Design Revision 01

eProjects Work Order Number: 1637041
Construction Contract Number: N40085-25-R-2611
Buildings: CEP 200 & CEP 209
Project Title: CEP 200 & 209 Office Renovations
Date: 25 April 2025

Design Revision Purpose

1. Response to PPIs

FRAMING PLAN FOR RTU SUPPORT

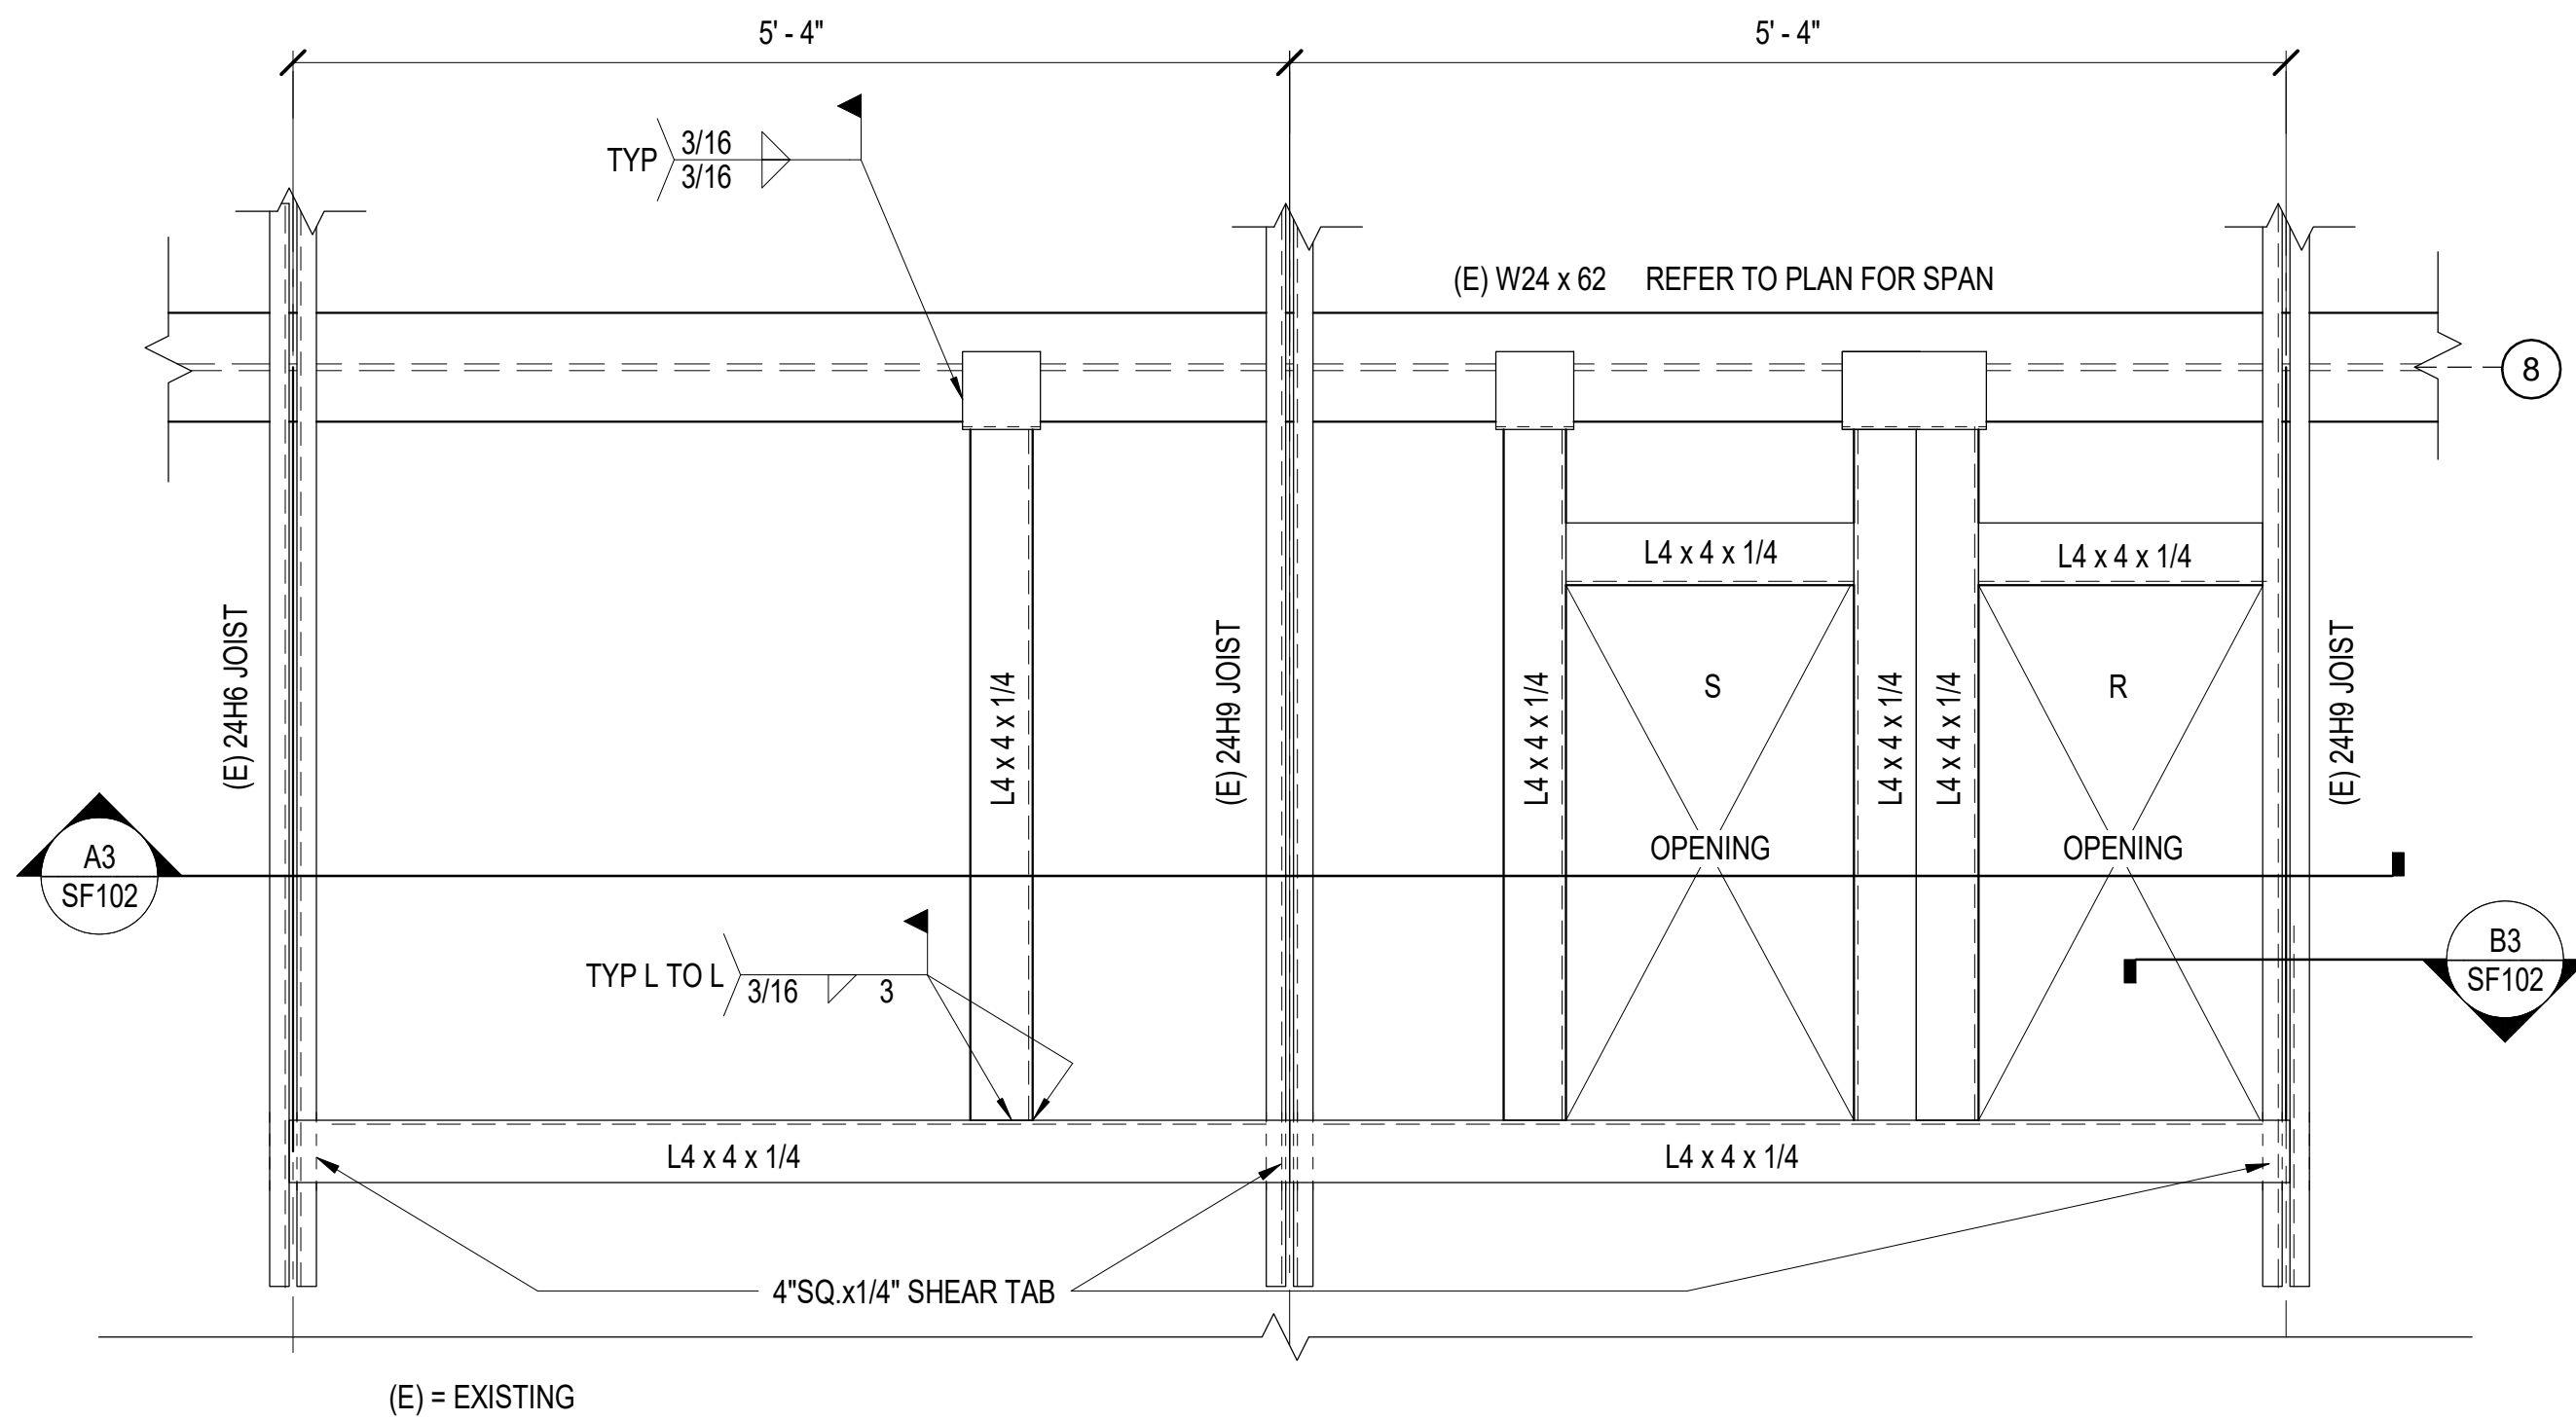
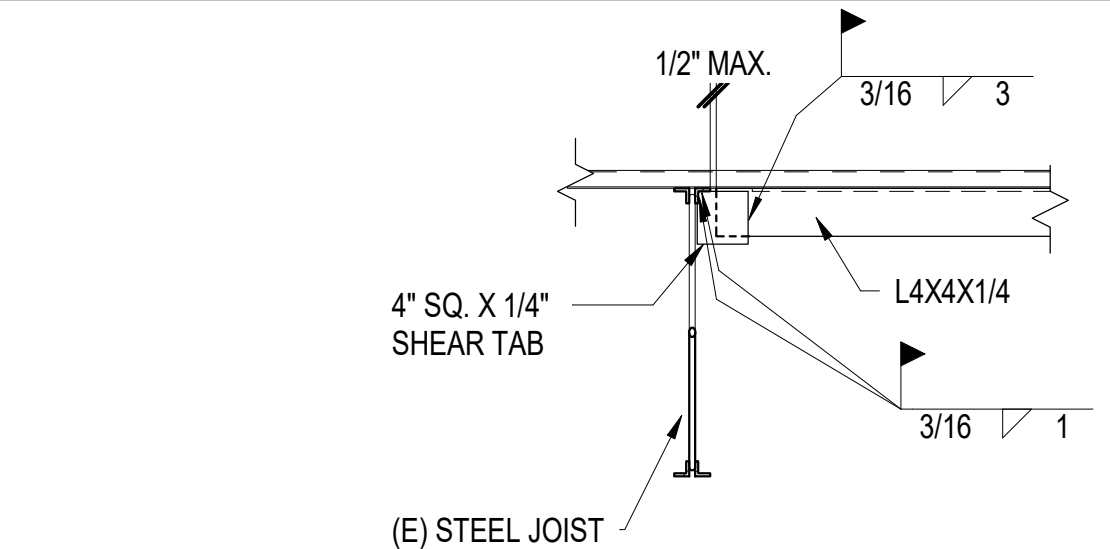
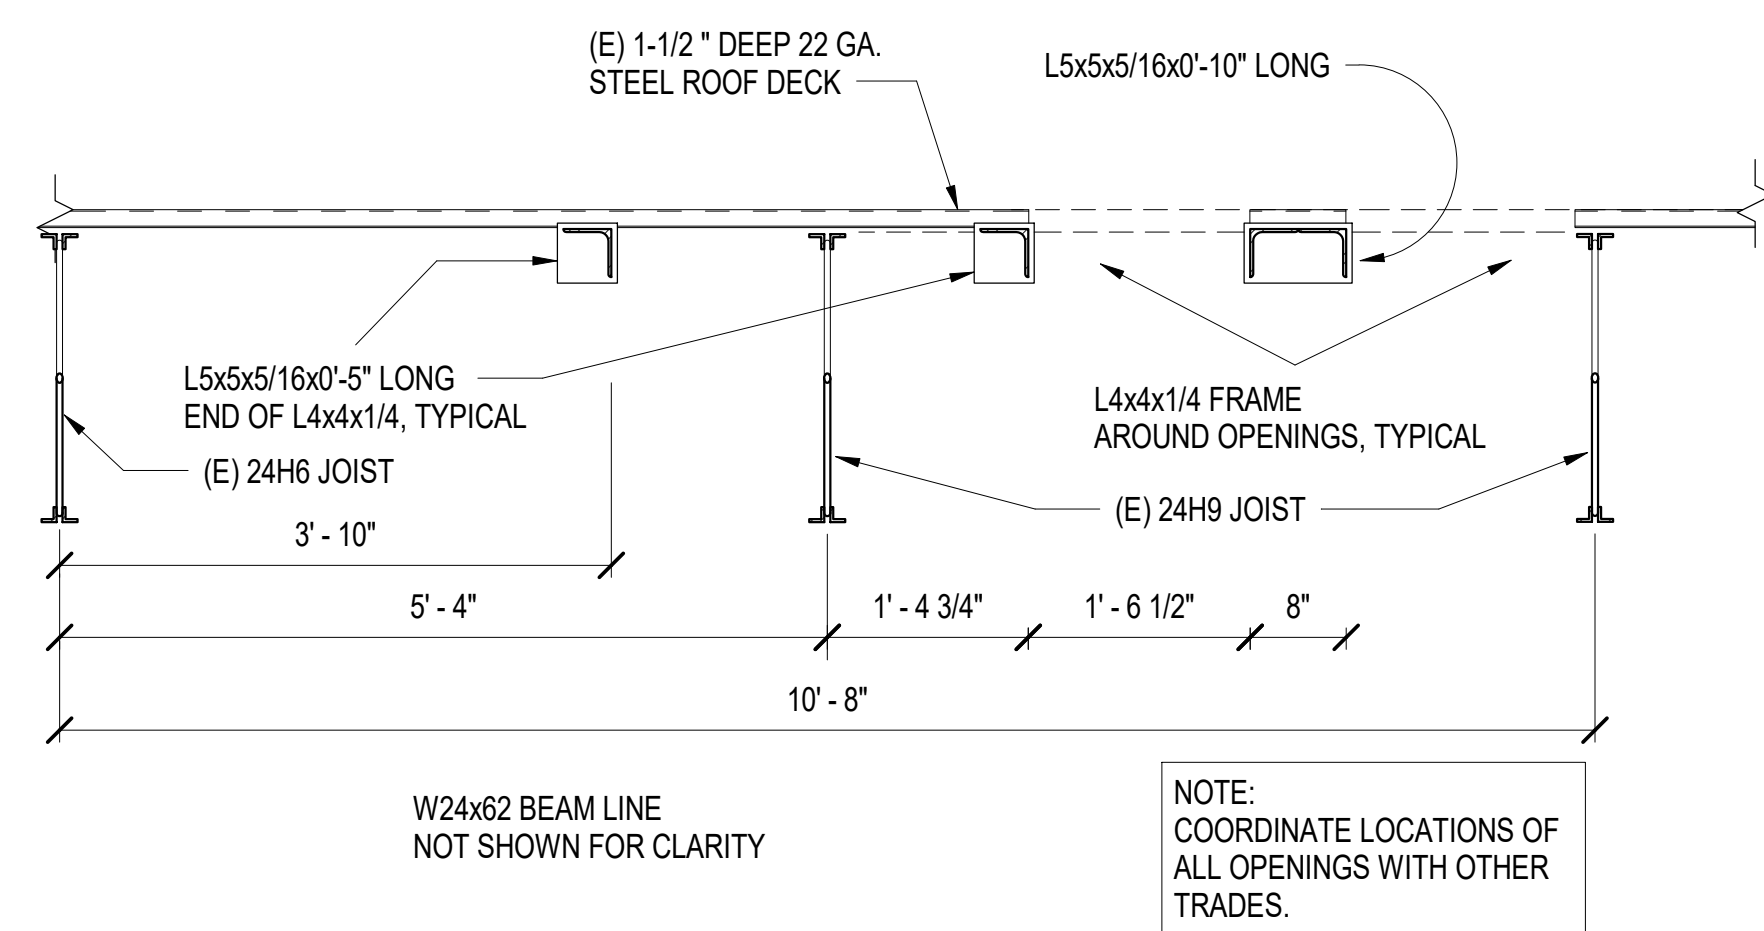
SHEET NO.		NAVFAC DRAWING NO.	SHEET TITLE
NO.	SHEET		
STRUCTURAL			
8.1	SF102	12.902.313	FRAMING PLAN FOR RTU SUPPORT – BUILDING CEP 200

A1 BLDG CEP-209 - PARTIAL LIGHTING PLAN - NEW WORK
1/8" = 1'-0"

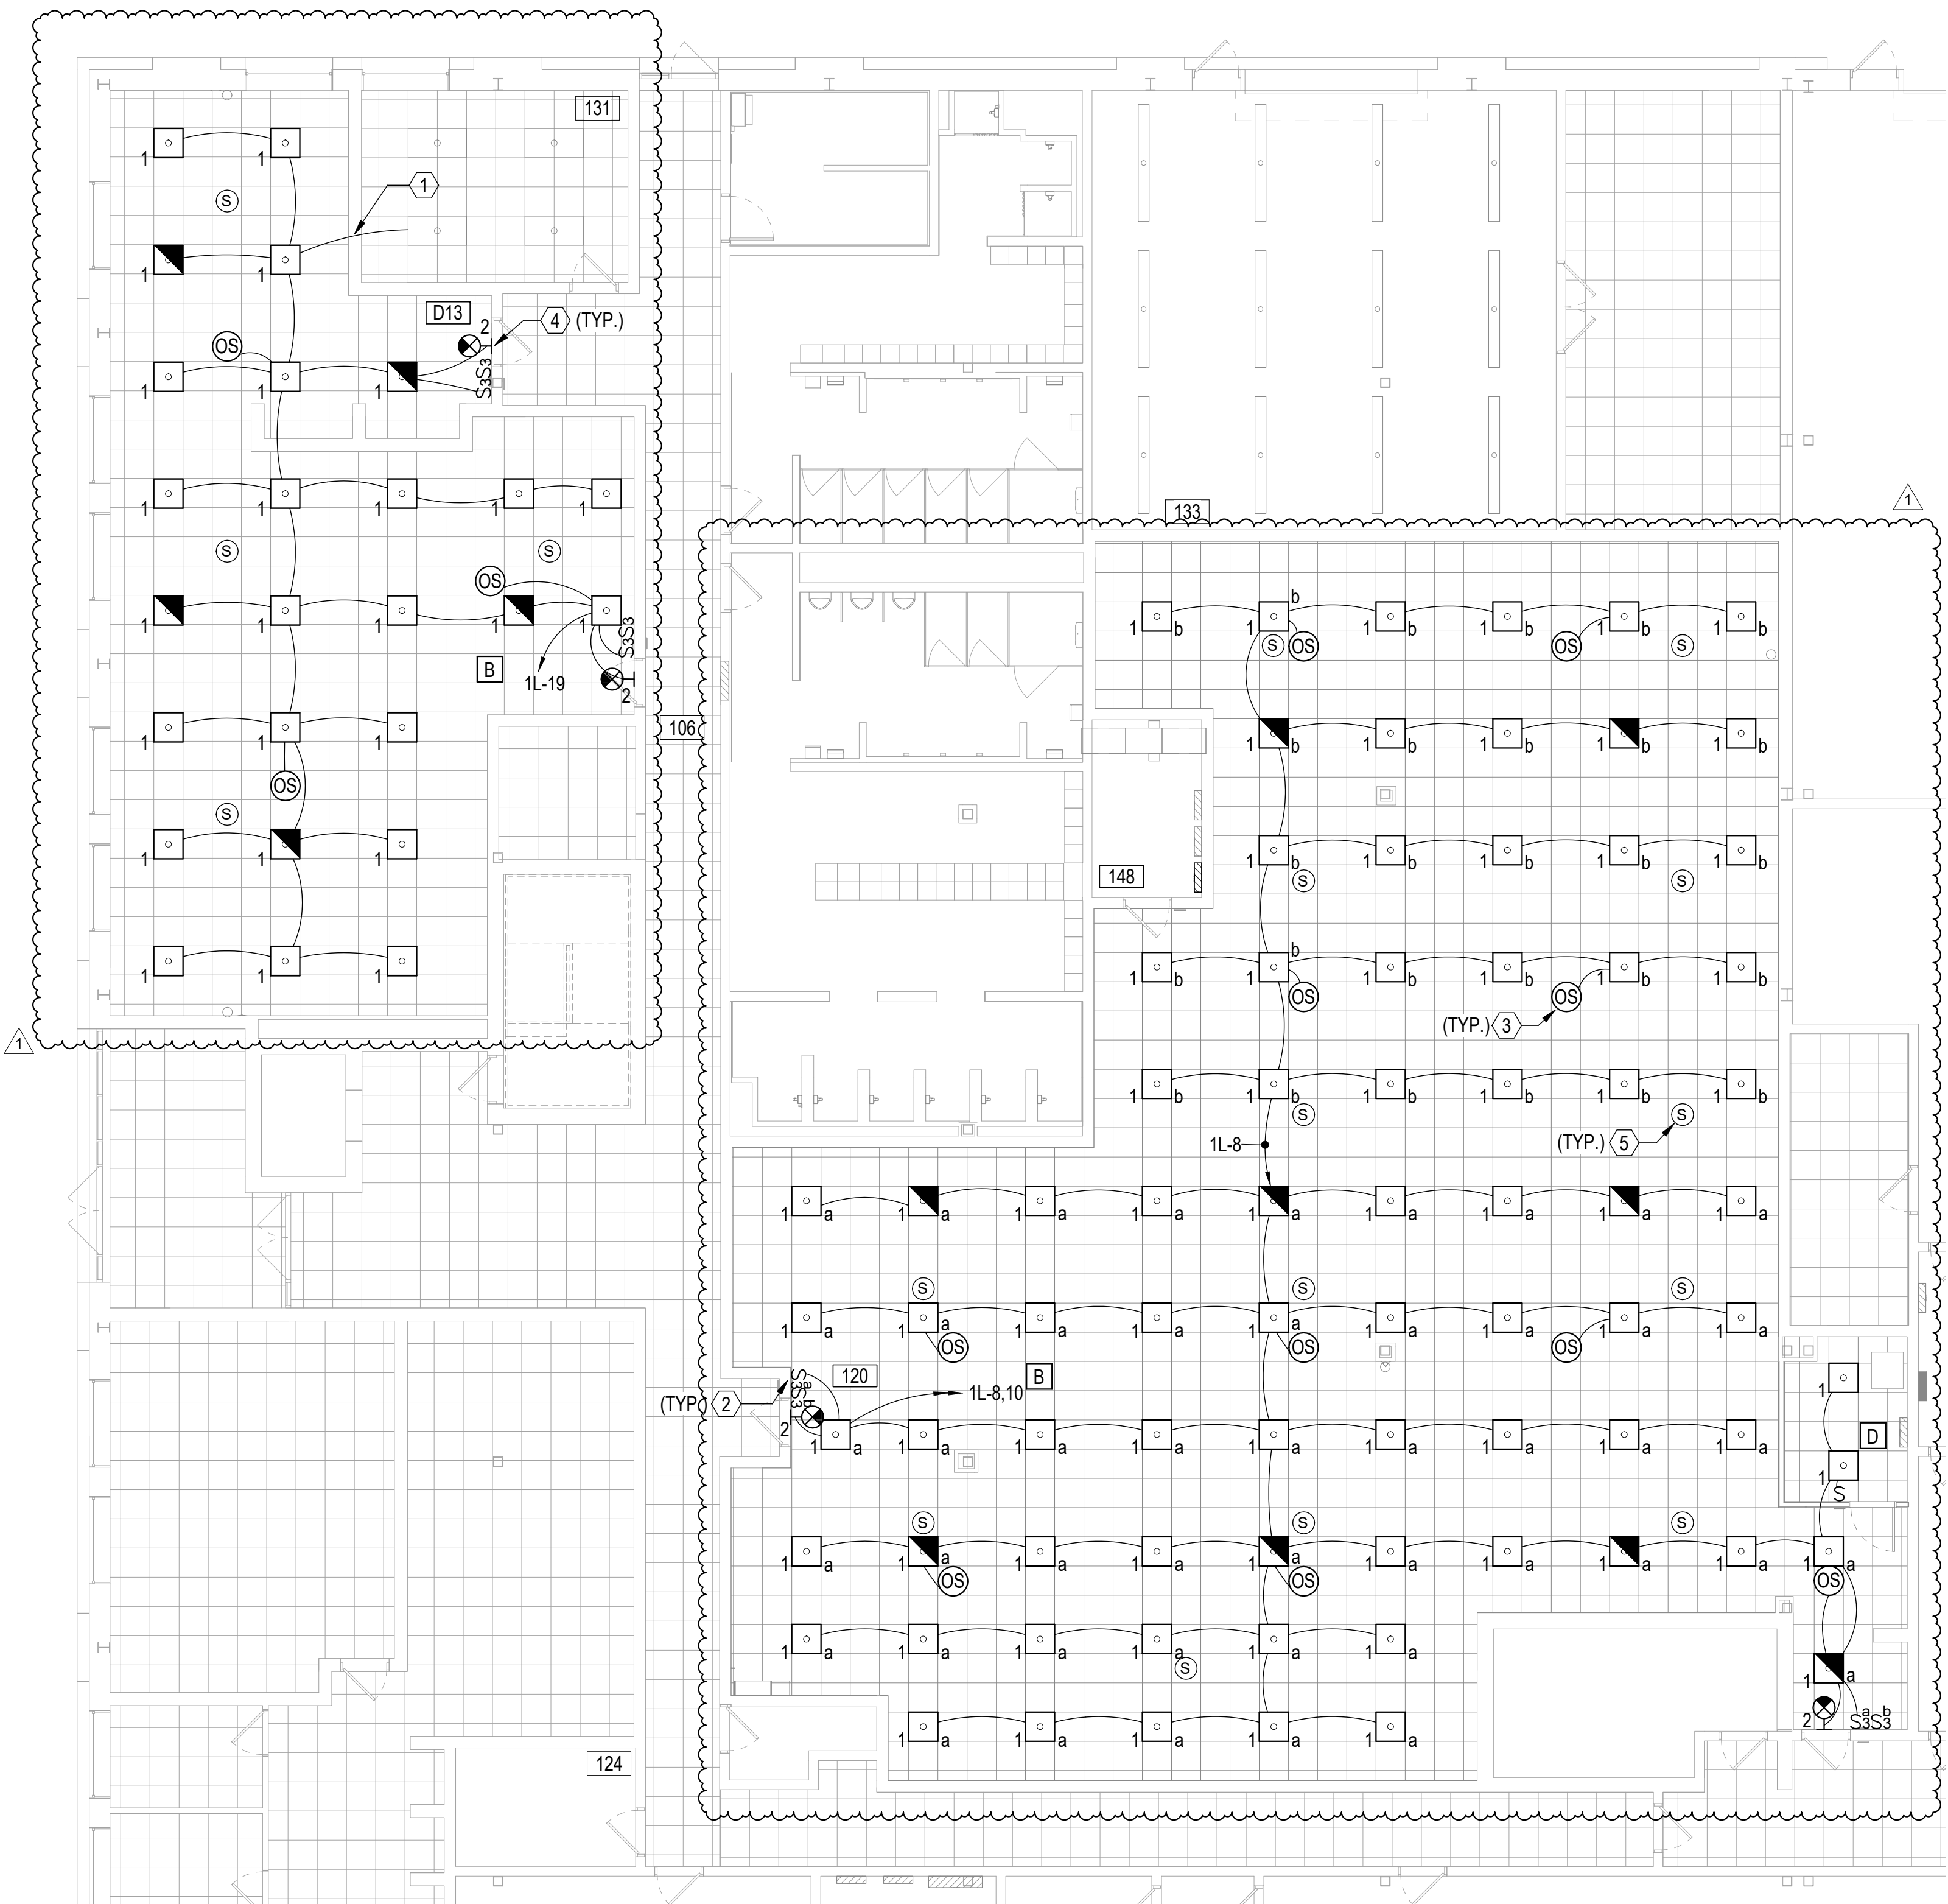
BLDG CEP-209 – PARTIAL LIGHTING PLAN – NEW WORK: Show locations of emergency lighting fixtures.
